HISTORIC AND DESIGN REVIEW COMMISSION

HDRC CASE NO: 2018-402
ADDRESS: 209 MADISON ST
LEGAL DESCRIPTION: NCB 740 BLK 3 LOT 13 & SW 25.075FT OF 12
ZONING: RM-4,HE
CITY COUNCIL DIST.: 1
DISTRICT: King William Historic District
LANDMARK: Greabner-Giles House
APPLICANT: Elisa Madrid
OWNER: Elisa Madrid
TYPE OF WORK: Enclose second-floor balcony
APPLICATION RECEIVED: July 23, 2018
60-DAY REVIEW: September 22, 2018

The applicant is requesting a Certificate of Appropriateness for approval to enclose a second-floor balcony.

EXHIBIT A

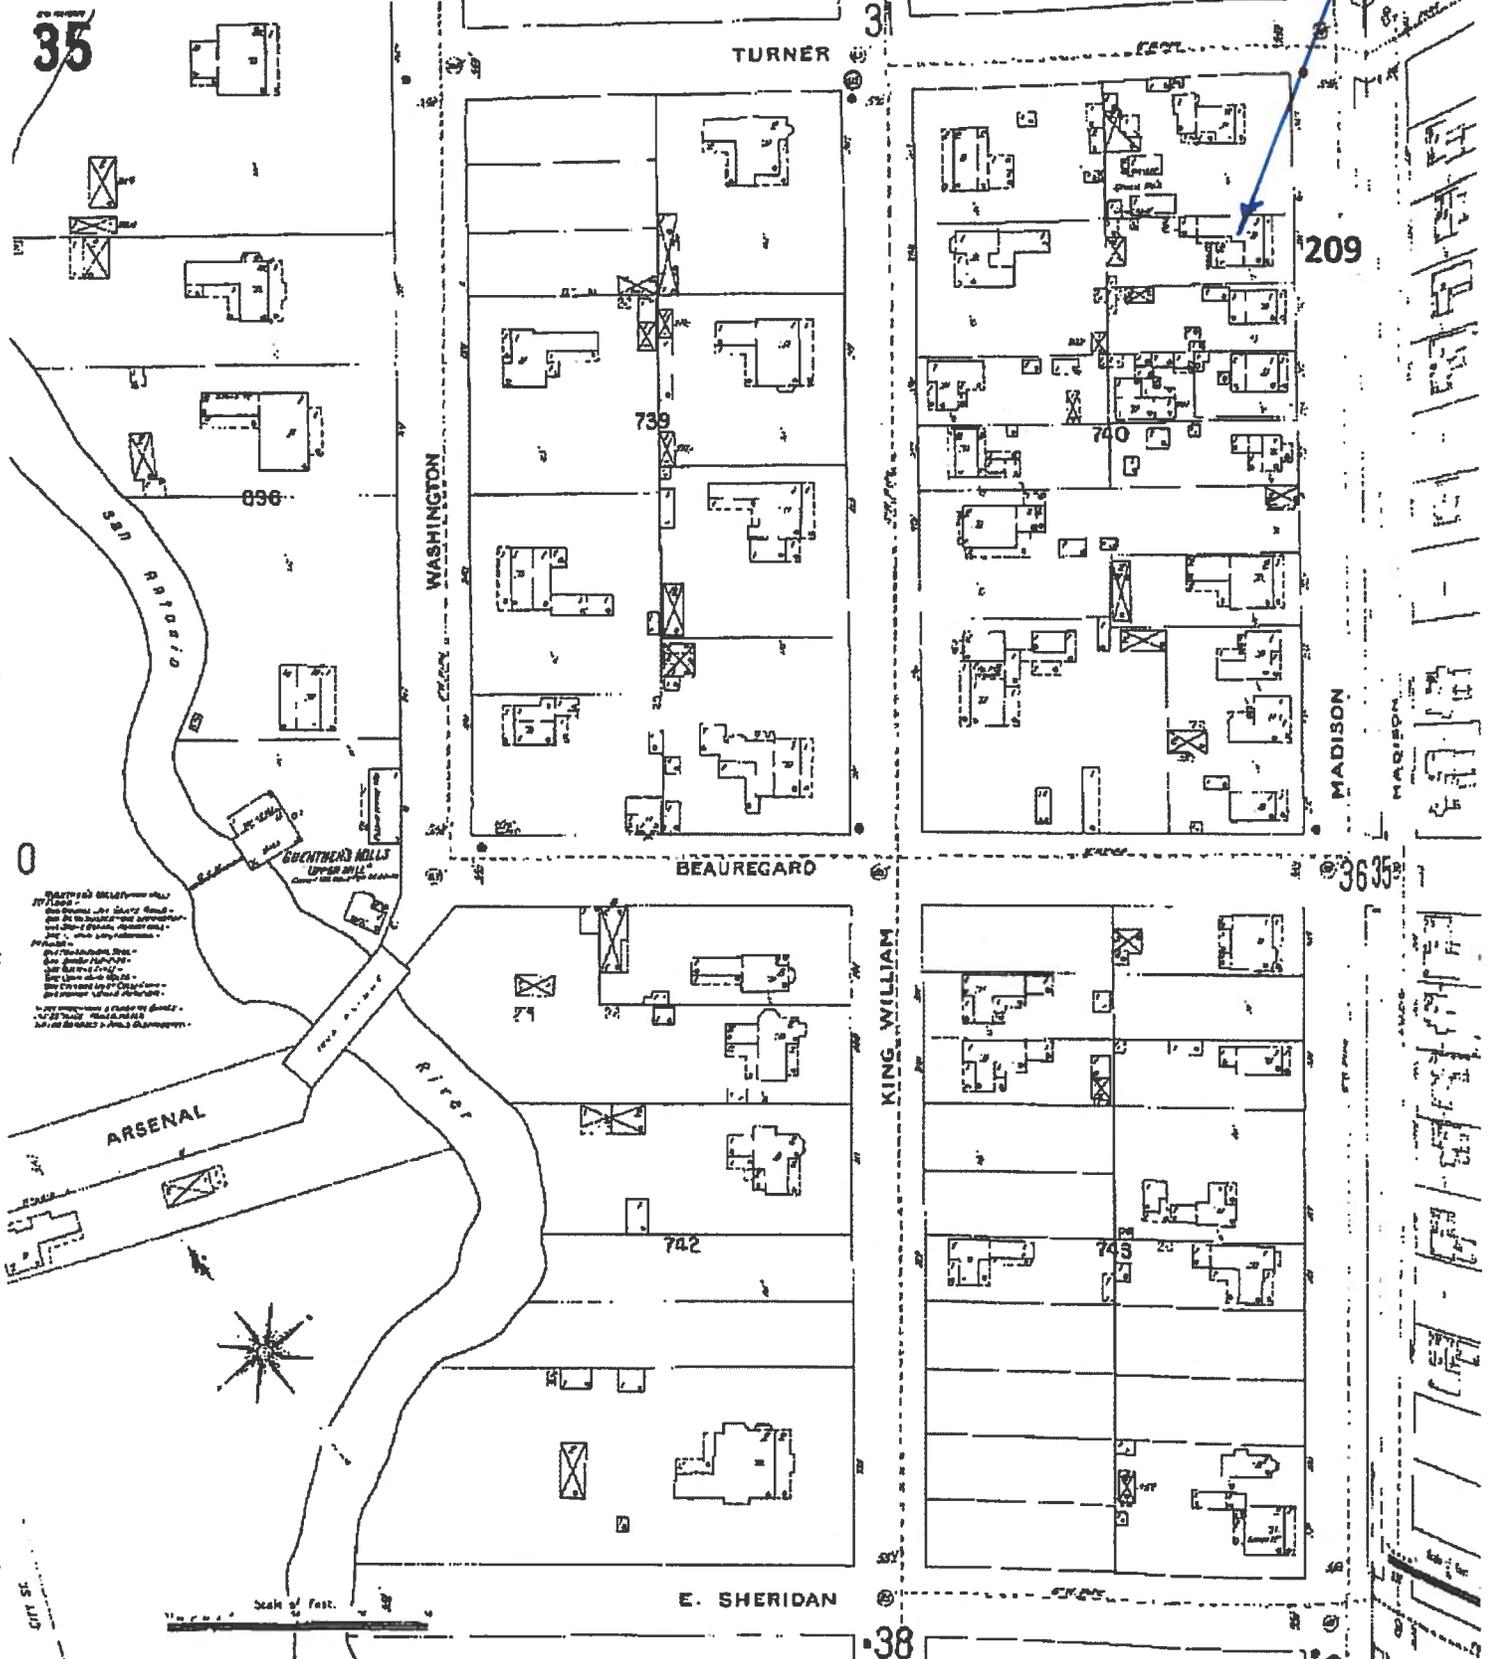
1. I reviewed the city furnished copy of the 1896 Sanborn Map. The map appears to show the lot in 1896 having the original home located on Lot 13. At some time after 1896, the home was expanded toward the right and one half of Lot 12 was conveyed. The current structure has been expanded into Lot 12. Attached is the Sanborn 1896 Map noted as **Exhibit A**.

INDENT:
2nd Level Closed Porch in
original construction of 2nd
level addition

EXHIBIT B

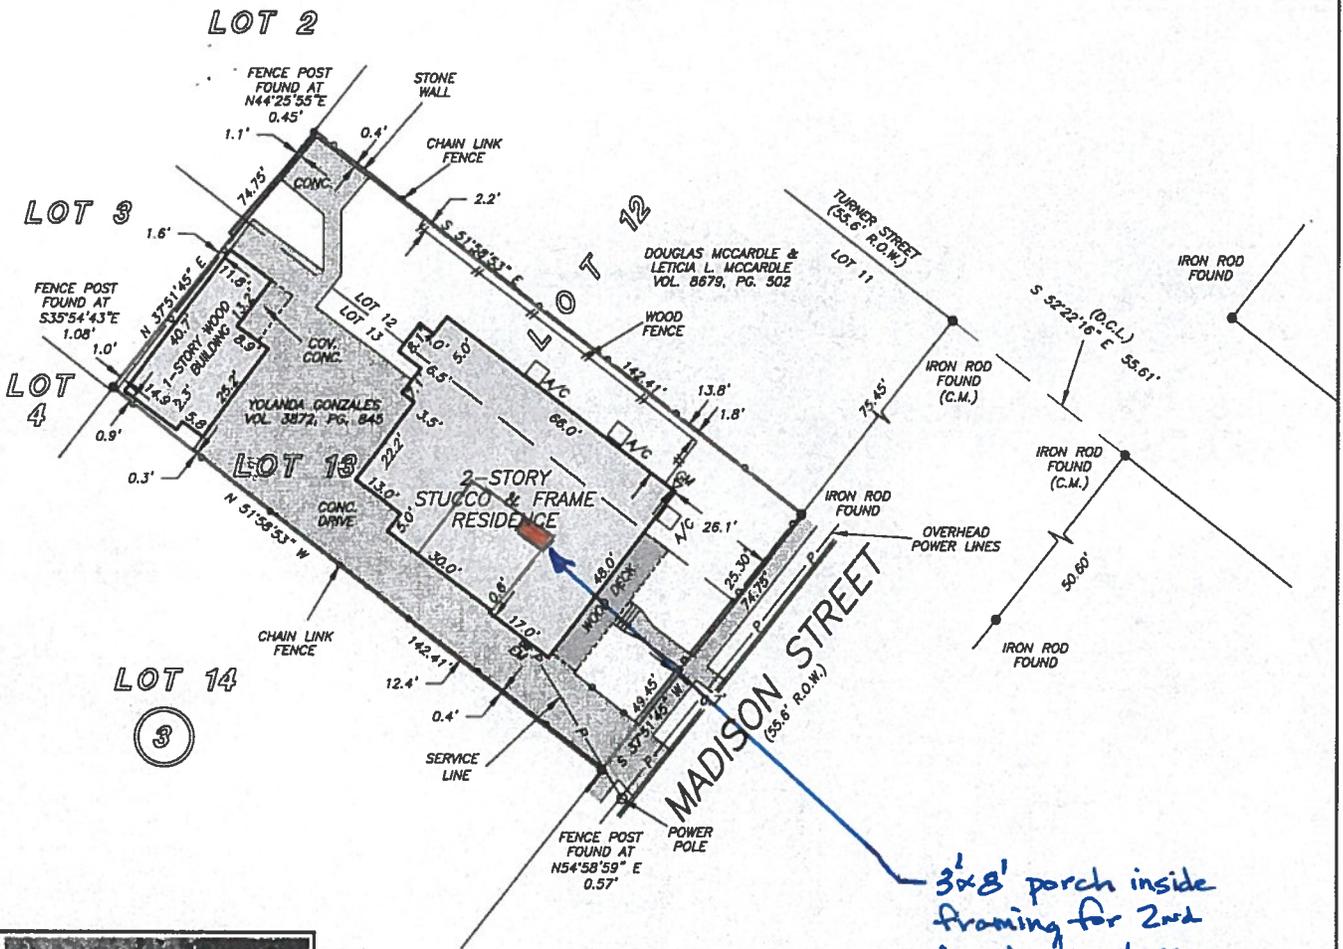
2. We have also attached the Survey of the current configuration, noted as **Exhibit B**. This survey has marked the location of the small porch near the center of the current existing structure.

3'x8' porch inside framing for 2nd level structure. Convert to waterproof and enclose with siding to match historical siding existing.

#1

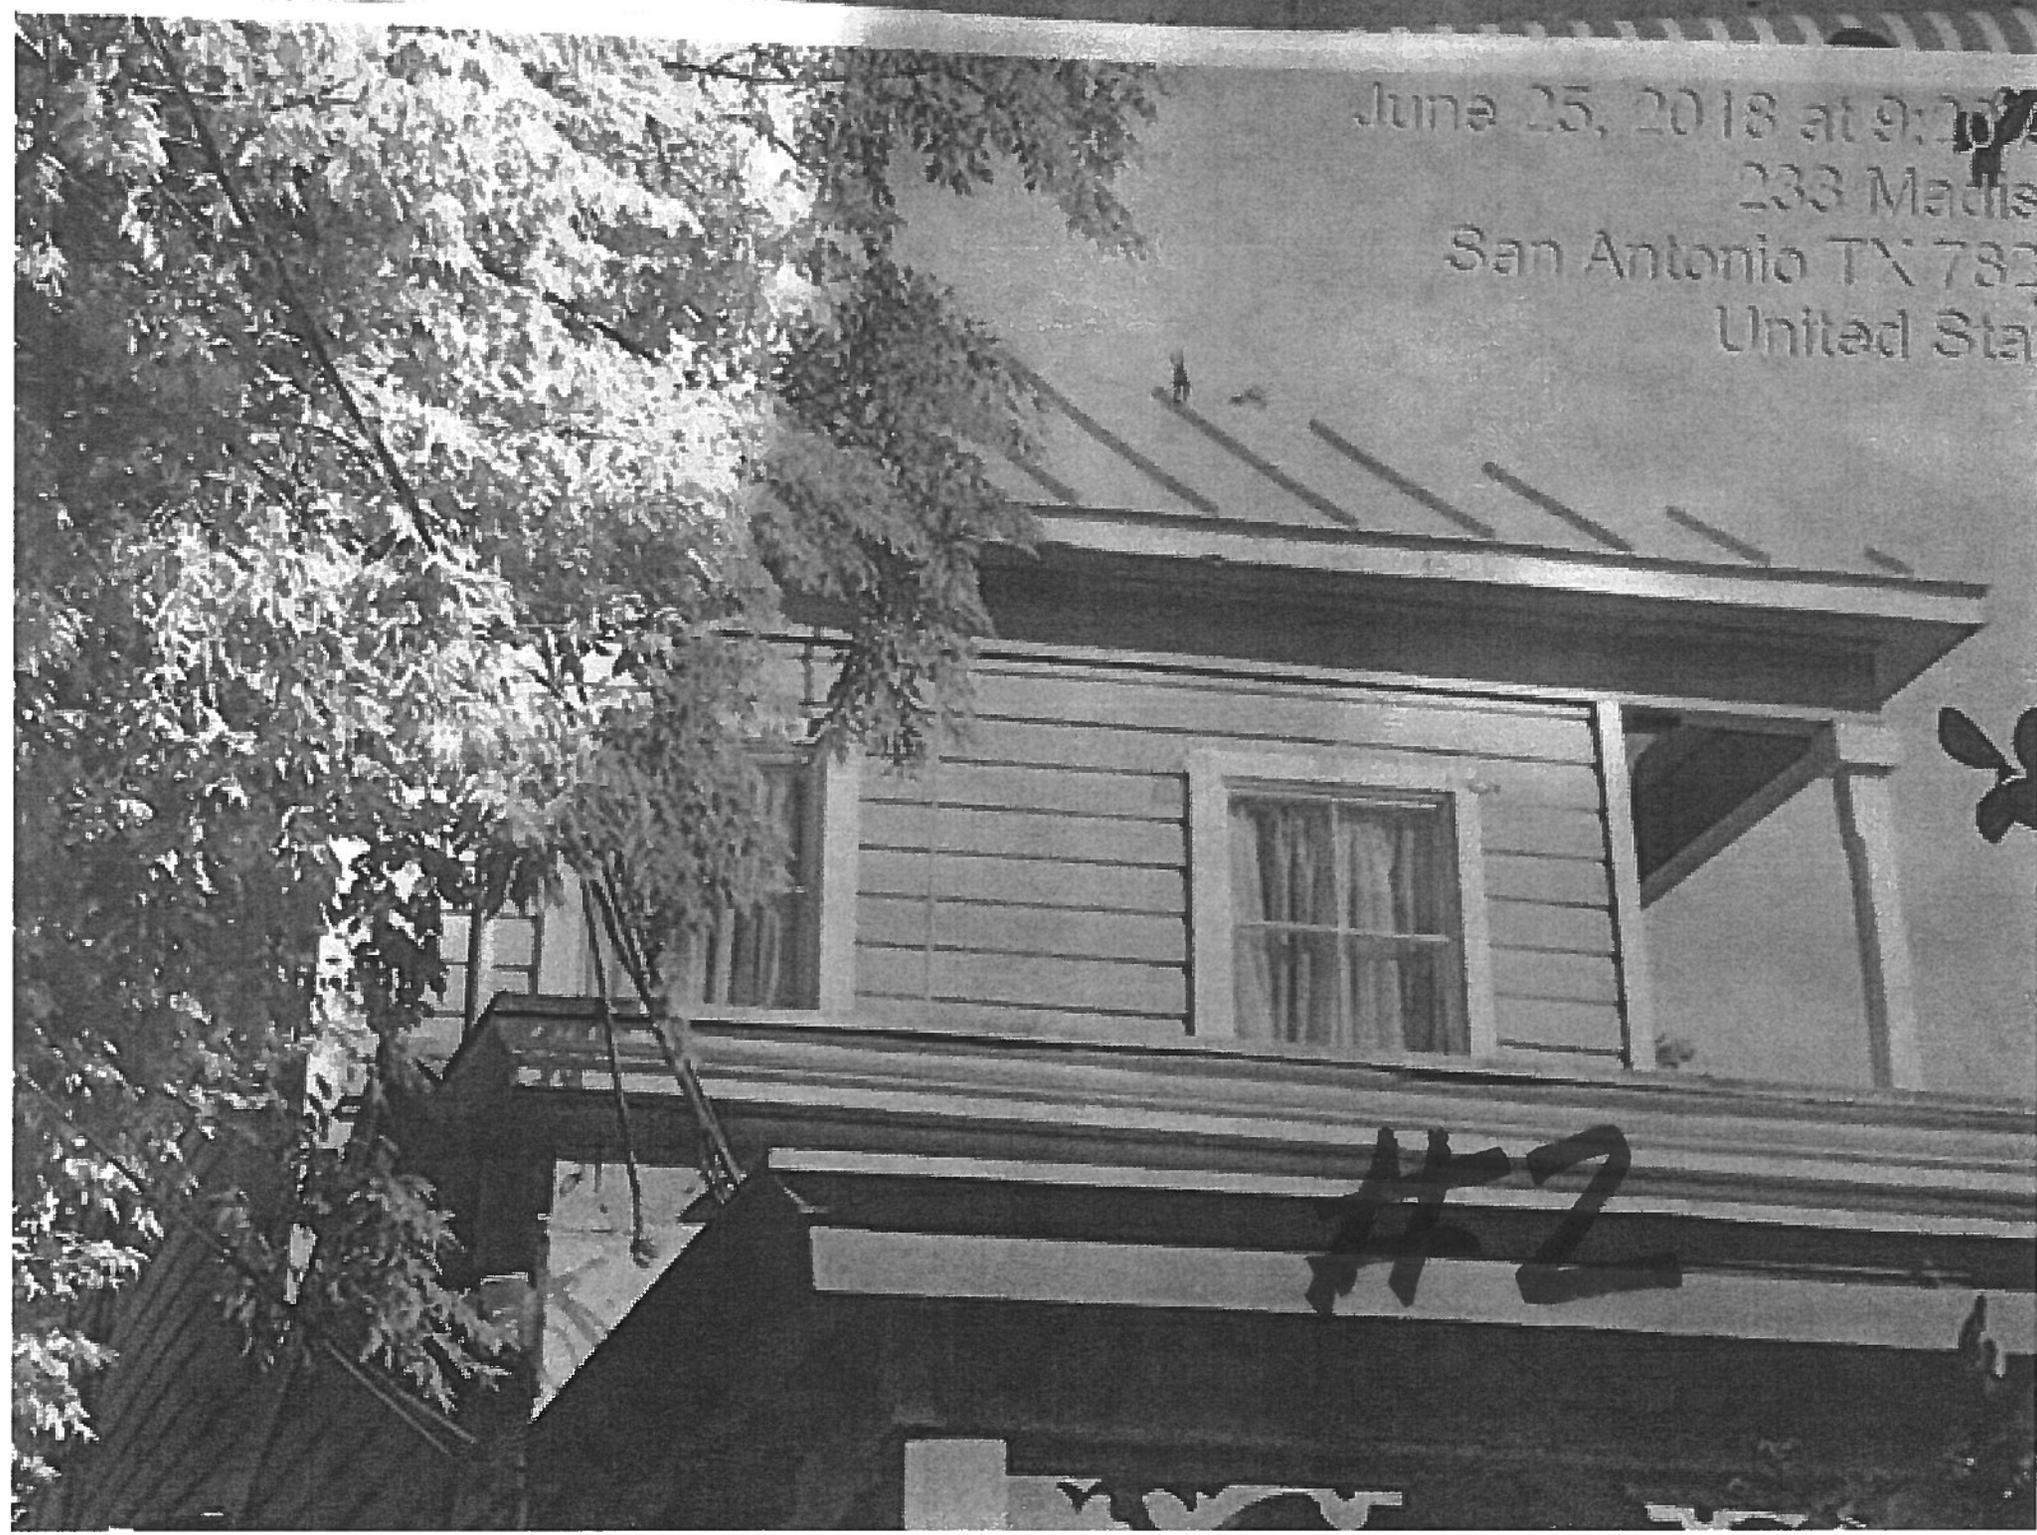
3. The original wood structure was built with the small observation porch located at the right front corner of the second level. That room was a bedroom but lacked a closet, as did bedrooms in most homes of this vintage. The exterior front elevation is shown in **Photos #1 and 2**.

#3

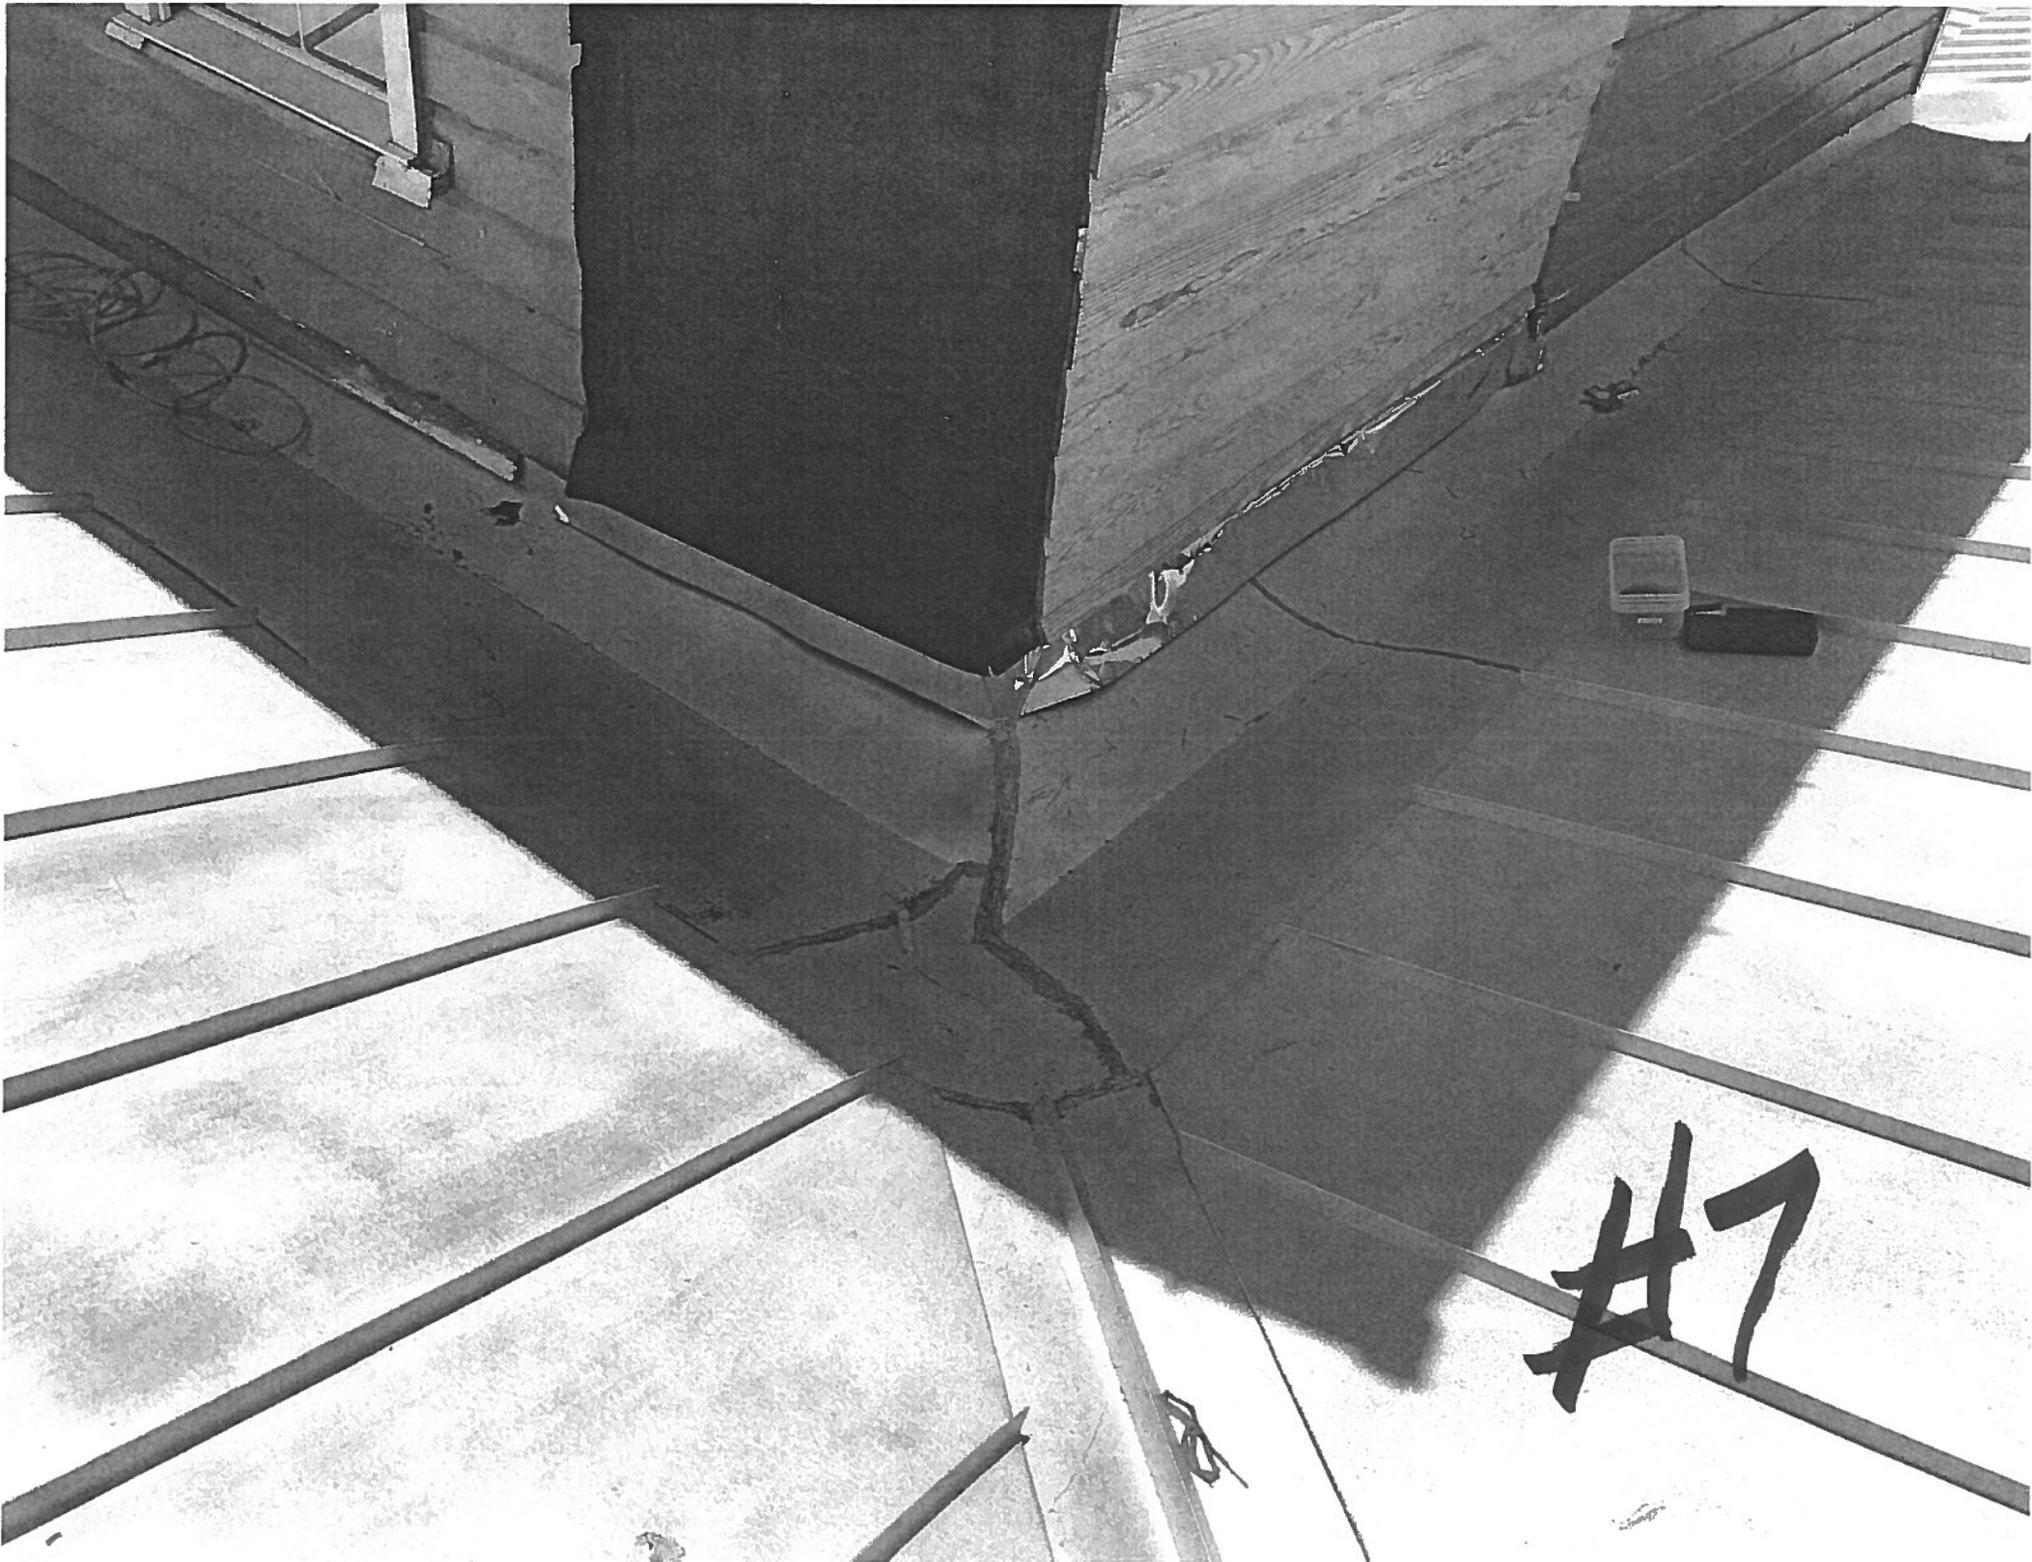
4. At the time of my inspection, I reviewed the roofing work in progress and show the new waterproofing at the exterior perimeter of the front right 2nd level corner of the home. That condition is shown in attached **Photo #3**. Note that the existing siding is a lap siding and the enclosure was in place for the waterproofing of this corner of the home structure.
